GROWTH MANAGEMENT DEPARTMENT STAFF REPORT
VILANO BEACH TOWN CENTER OVERLAY DISTRICT
January 10, 2024 Public Meeting
VBTCDR 2023-04 – 165 Vilano Road Restaurant (Snappers)

To: North Coastal Design Review Board
Staff: Teresa Bishop, AICP, Planning Manager
Date: January 3, 2024

Summary of Request: Applicant is requesting design approval to renovate and add an expansion to the existing building.

YIELD ANALYSIS PLAN FOR 165 VILANO ROAD
PRE-APPLICATION-MEETING CONCEPT PLAN
 ST. JOHNS COUNTY, FLORIDA

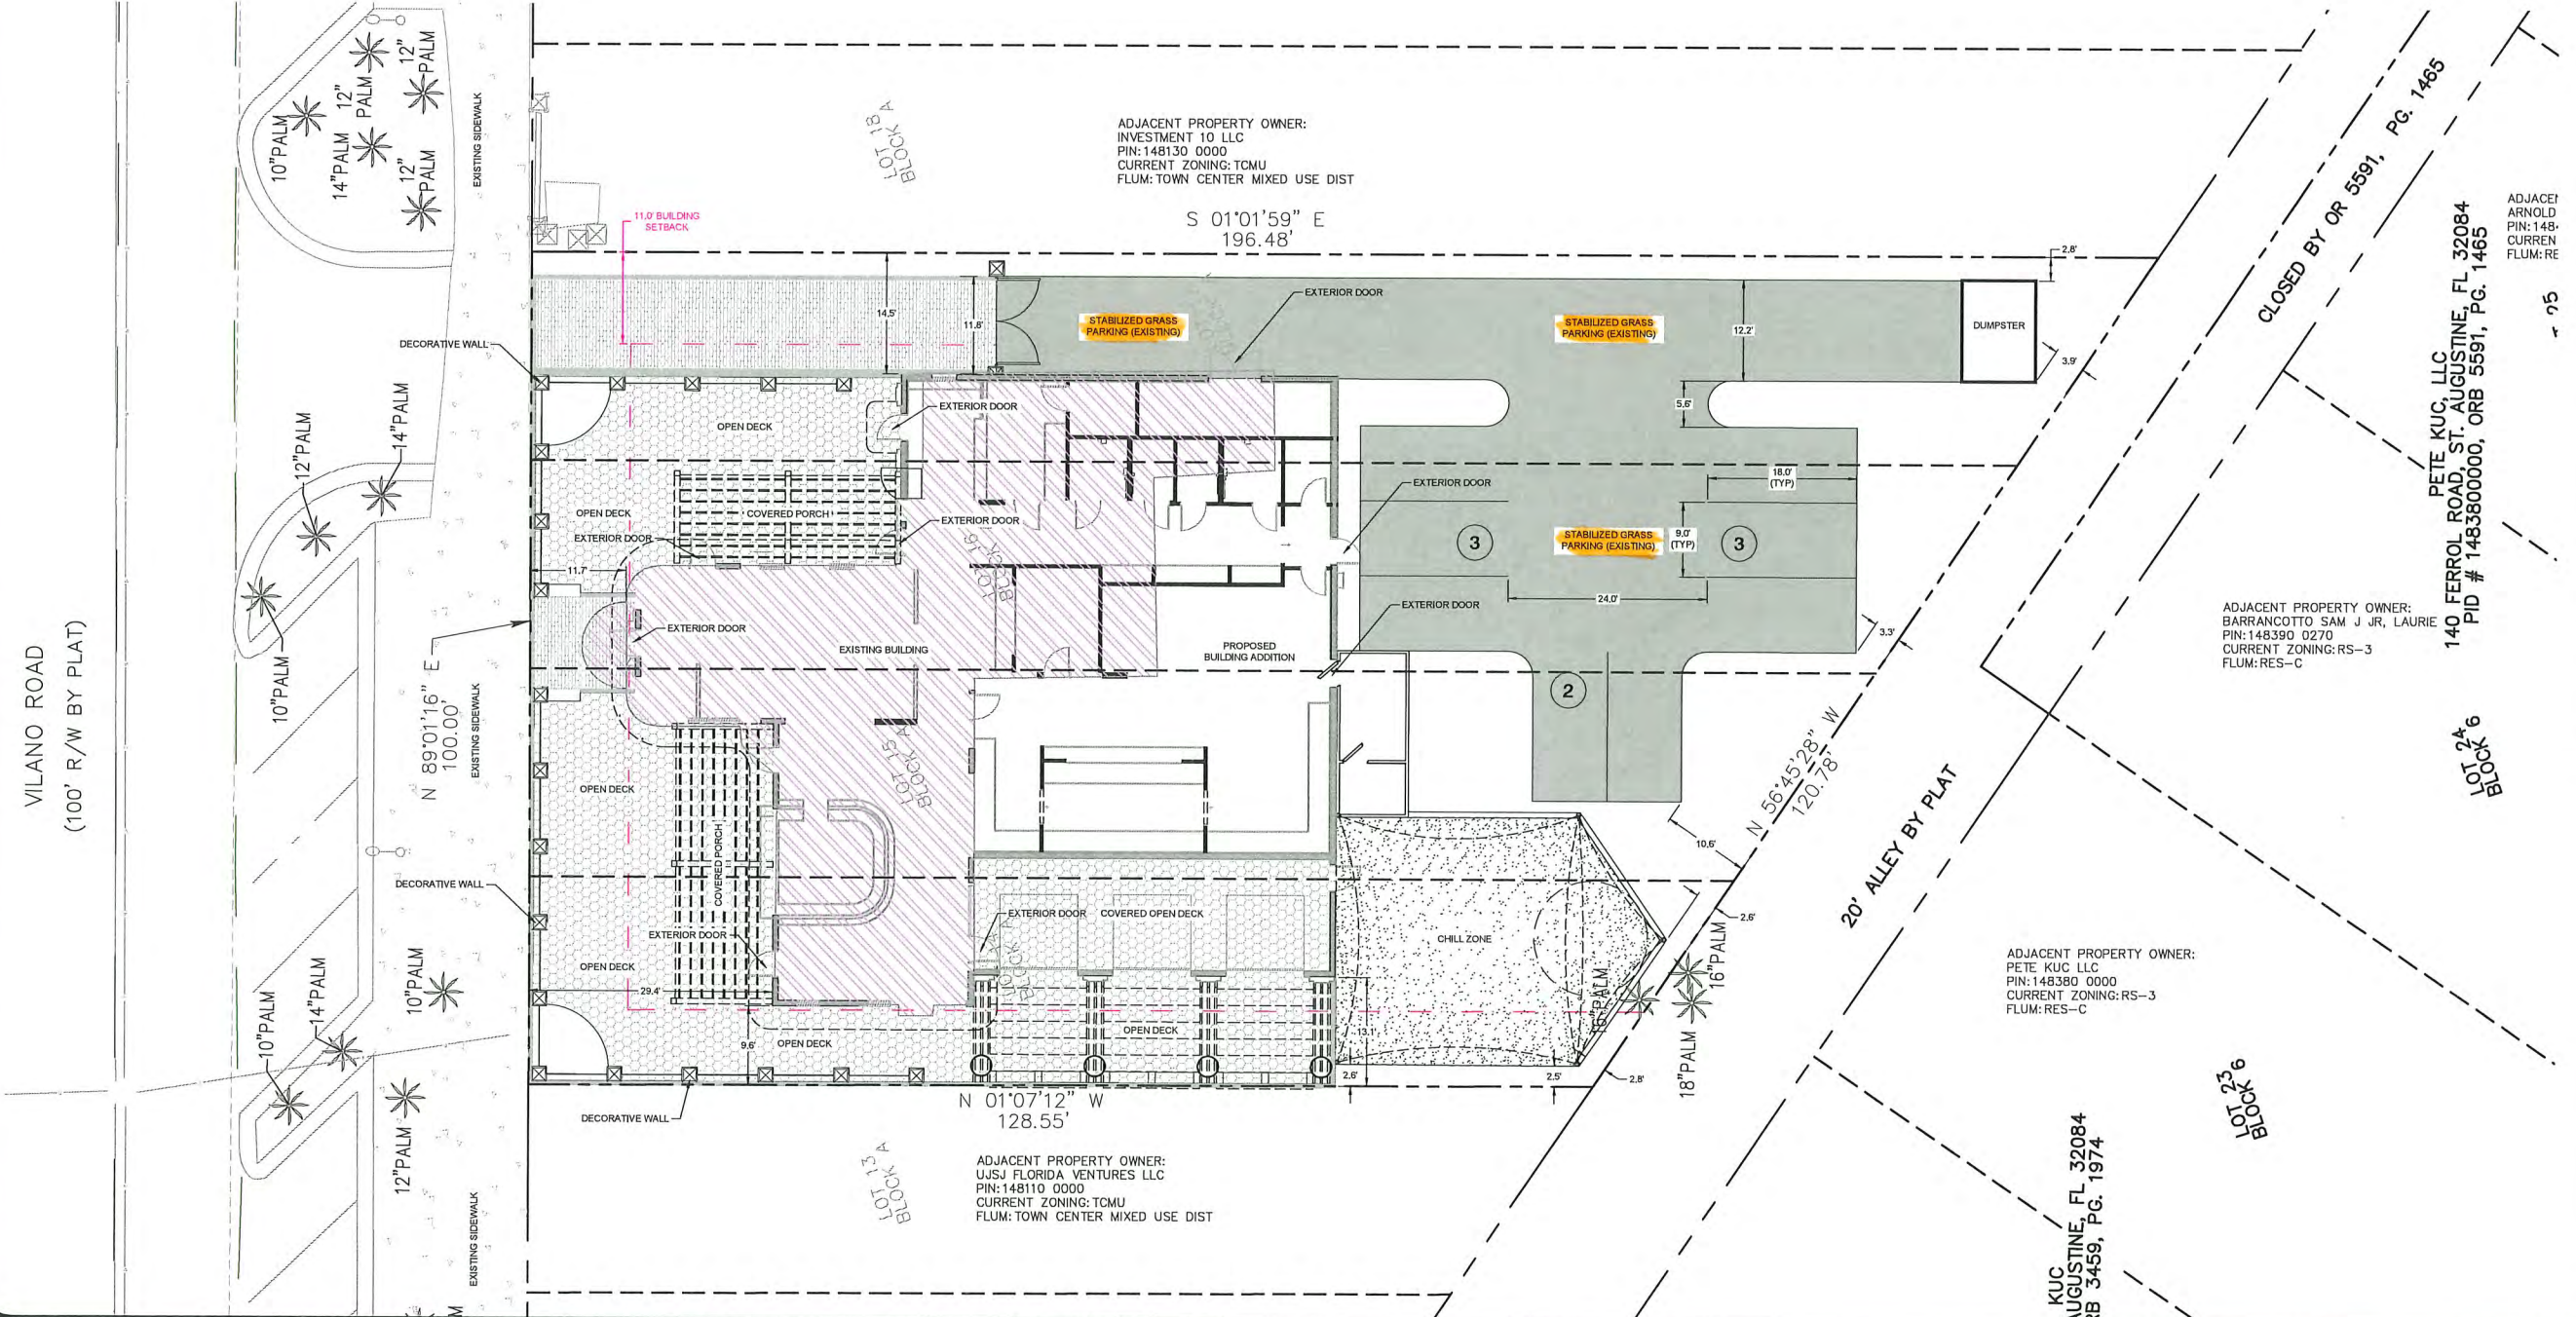
The proposed site plan provides eight parking spaces are being provided. Section 3.10.05.J.1 of the LDC requires in part, there shall be a minimum of 2 off street parking spaces per 1,000 square feet of non-residential space... At this time, the applicant has not provided the square footage of the building or depicted the parking spaces on the site plan. The site plans shows stabilized grassed parking area, with no spaces. The 1st Floor Plan proposes over 100 seats within the dining area, open deck, bar, sushi bar, and event area. The applicant should provide adequate parking; however, the Land Development Code allows for no or reduce parking if restoring a historic structure.

Section 3.10.04.A.9. Transmission, phone and cable boxes will be placed in the rear of the development and decorated in a manner compatible with the architectural style of the building. These utility elements are not shown on the site plan. The DRB may want to ask the applicant to provide where such utility elements are located and how those are screened.

Landscape Plan (LSHS)

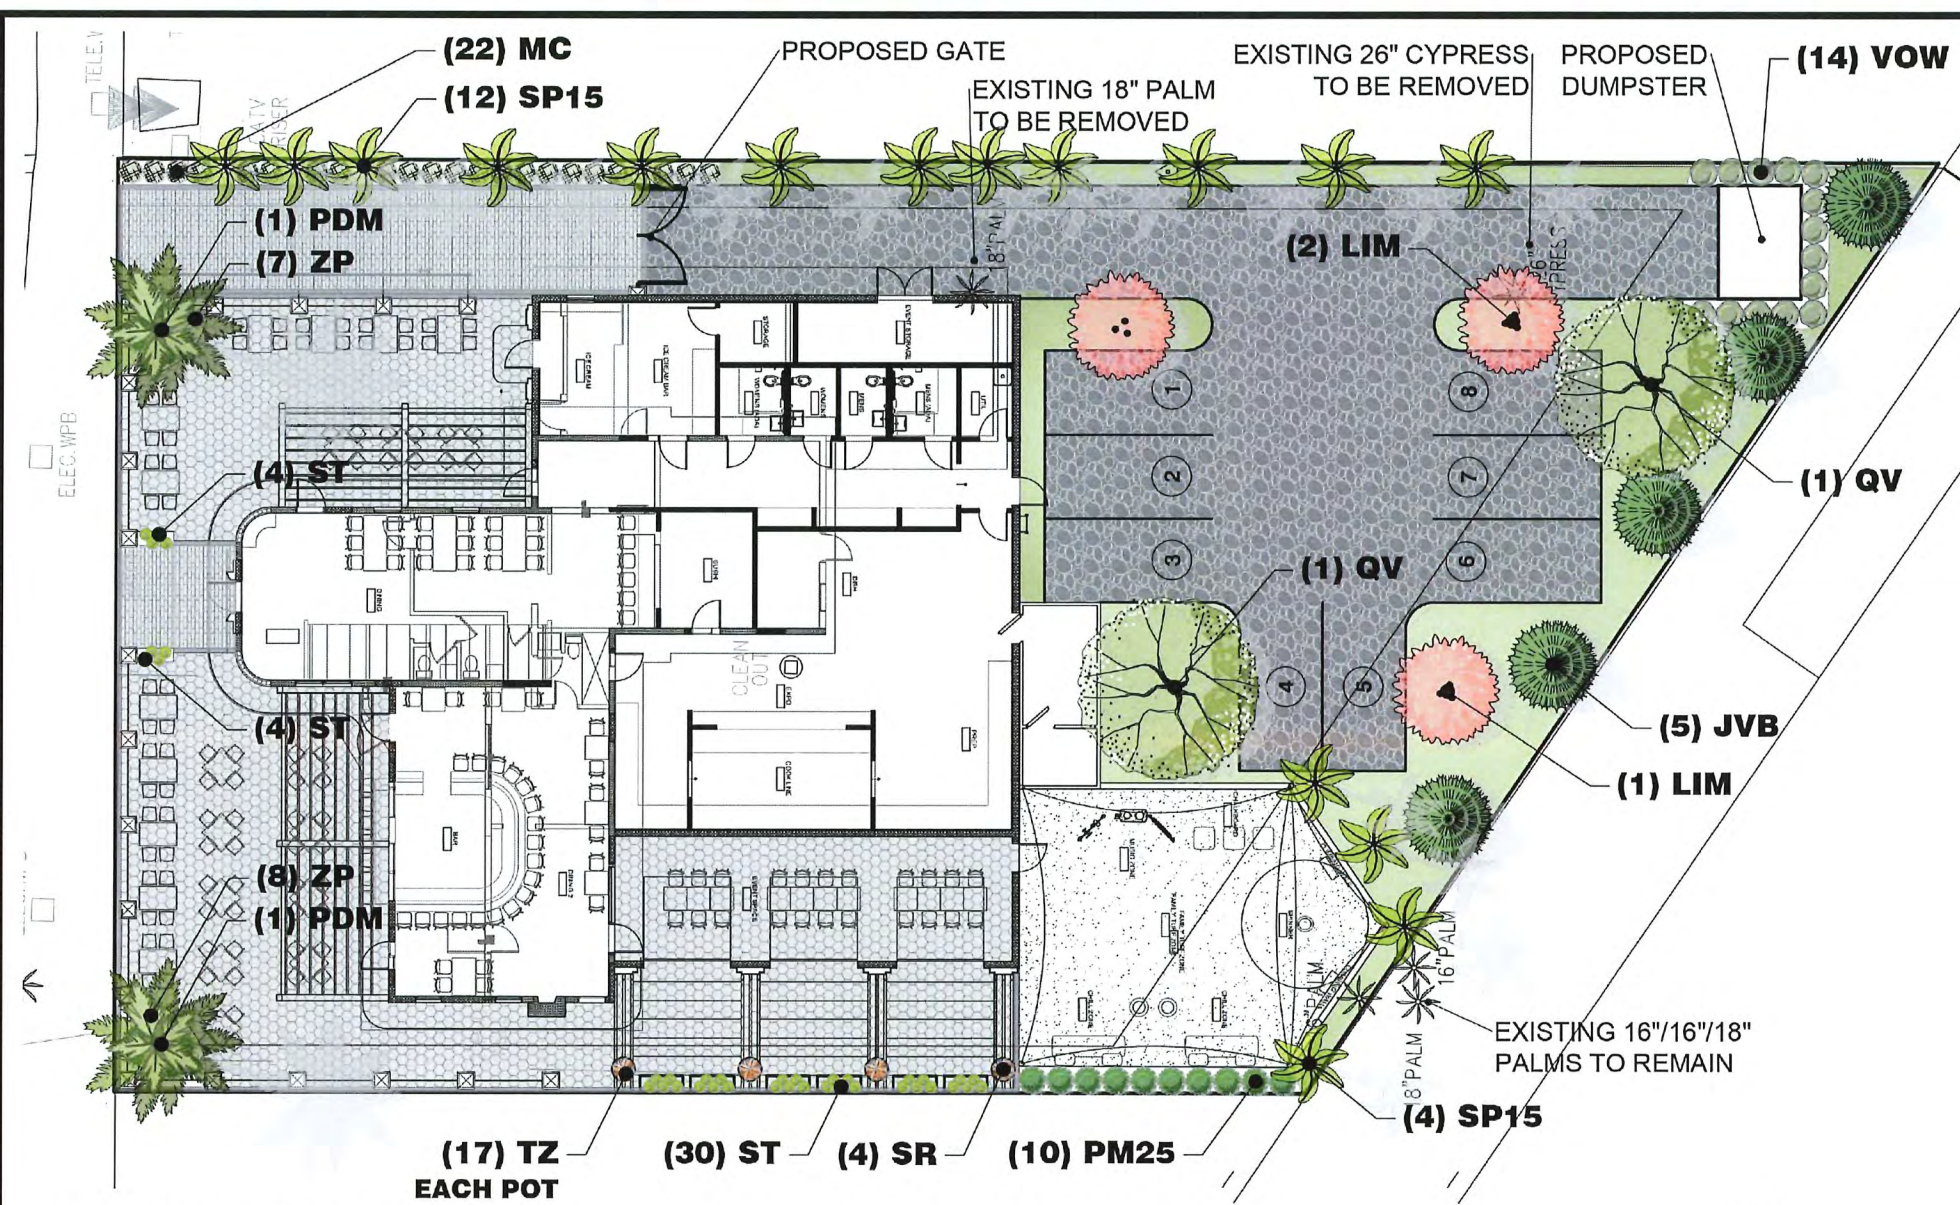
The Landscape Plan currently does not comply with the LDC. Landscaping will need to be reviewed by the DRB in future.

Section 3.10.05.L. Landscape. Landscaping, buffering and screening is proposed according to the LDC and TCMU regulations. The landscape site plan provided does not comply with the LDC.

Lighting & Signage Details

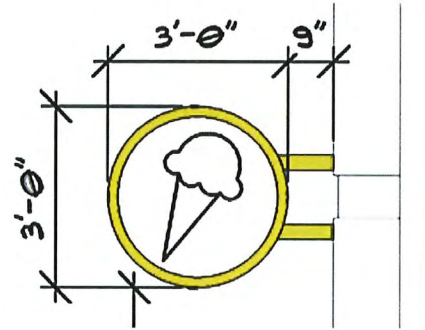
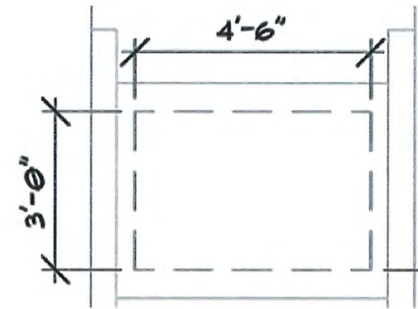
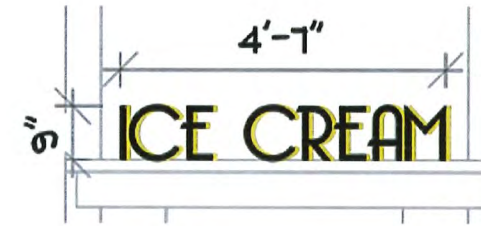
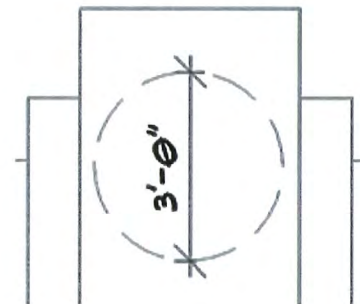
The applicant has proposed eight sign types for the building. The applicant needs to condense these signs for compliance with the LDC. The Snappers sign (Sign 4) and the Ice Cream Main Sign (Sign 2) appear consistent with LDC Section 3.10.05.I.3.c, for two identity signs on one façade; however, the ice cream cone design (Sign 1) and Ice Cream identity sign (Sign 3) needs to be incorporated into the Ice Cream main sign and not be stand-alone. The building identity, main restaurant brand (Signs 4 and 5) need to be incorporated into one sign for compliance with the Code. The DRB will need to provide if the Menu Board (Sign 7) and the Sidewalk Teaser (Sign 8) are consistent with the Land Development Code, as Section 3.10.05.I does not appear to address this type of signage. Signage colors, materials, and renderings were not provided with this application.
